Warranty Bulletin**95-33**Date: **August 1995**Section: **03**Subject: **"U" BRACKET ADDED TO THE RADIATOR SEALING FRAME - H3
VEHICLES WITH PLASTIC FUEL TANK**

FIGURE 1: REAR ELECTRIC COMPARTMENT 22058

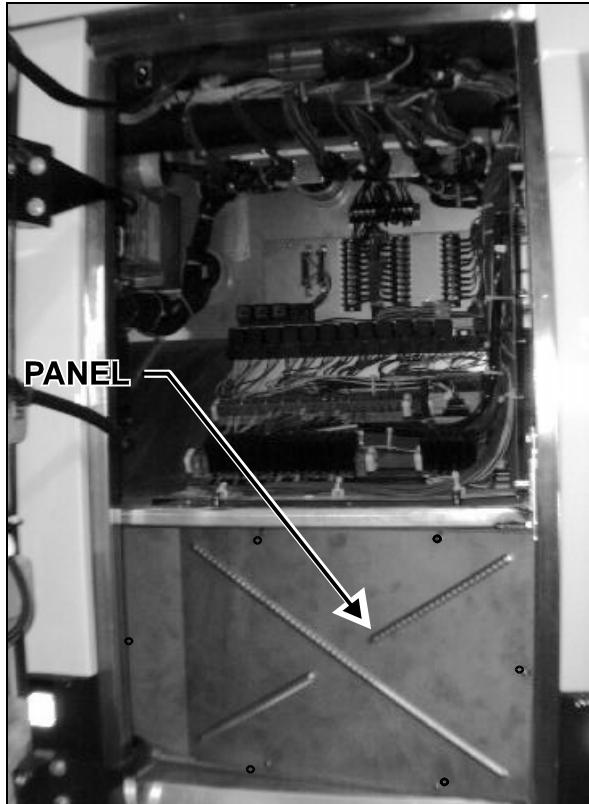
1. Open rear electric compartment.
2. To get access behind sealing frame and place washers on rivets, remove the panel covering preheating system. This panel is located in the rear electric compartment (see figure 1).
3. Open radiator covering door.

FIGURE 2: RADIATOR COMPARTMENT

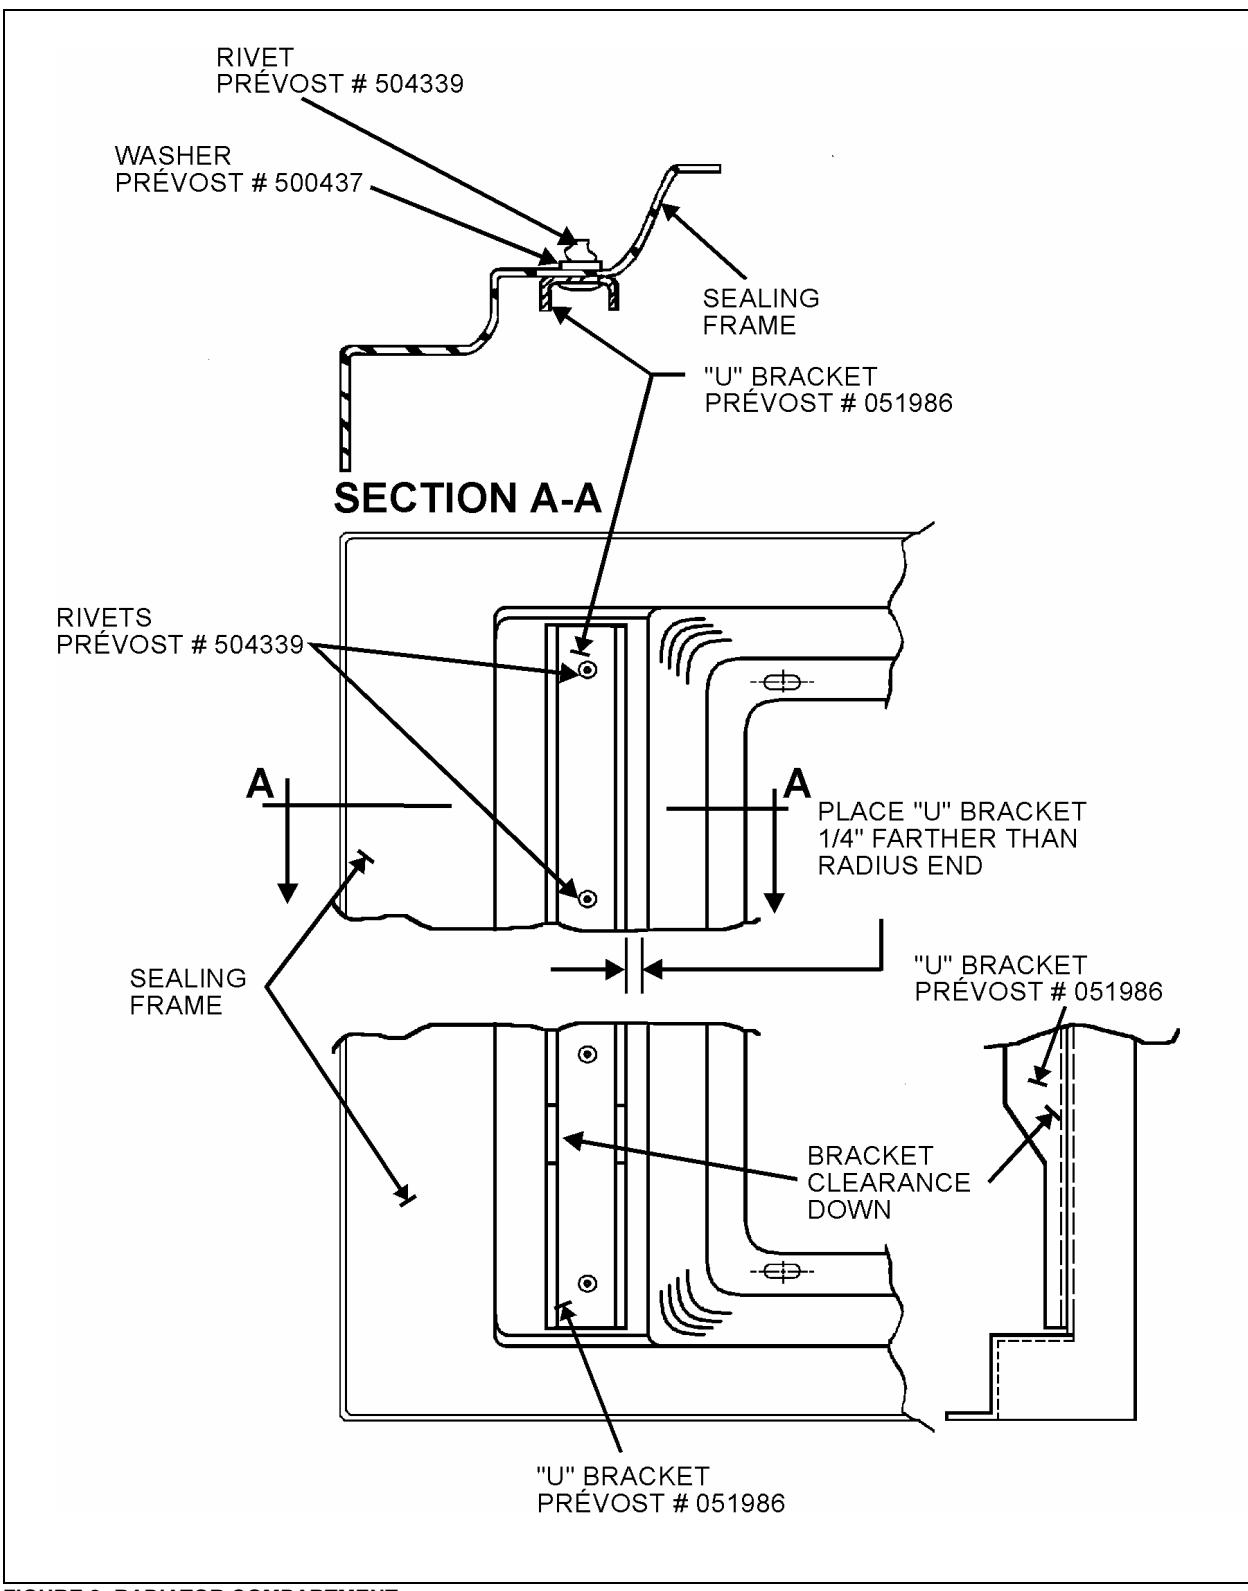
On the above mentioned vehicles, a "U" bracket must be installed to increase radiator sealing frame's stiffness. To perform this modification, proceed according to the following procedure.

4. Place "U" bracket on radiator sealing frame. Horizontally, the bracket should be 1/4" farther than the radius end. (see figure 2). Vertically, center "U" bracket on sealing frame.
5. Drill sealing frame with a 1/8" drill in the "U" bracket holes (7).
6. For each hole (7), place pop-up rivet and washer (see figure 2, Section A-A).
7. Reinstall preheating system panel.
8. Close compartment doors.
